REMARKS

ANNOTATED, MARKED-UP DRAWING

Fig. 1
PRIOR ART

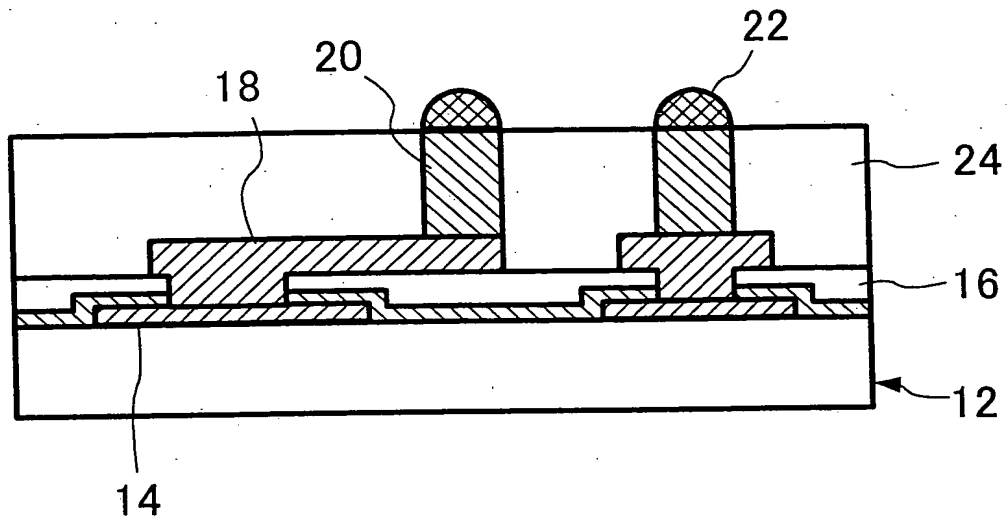
Responsive to the Examiner's requirement, the drawings have been corrected as indicated in red ink in the attached annotated marked-up drawings, whereby Figs. 1-4 have been denoted as "PRIOR ART". Also, the conductive post in Fig. 3 has been denoted by reference numeral 20, as described in paragraph [0018] of the present application. The above noted drawing corrections have been incorporated into the
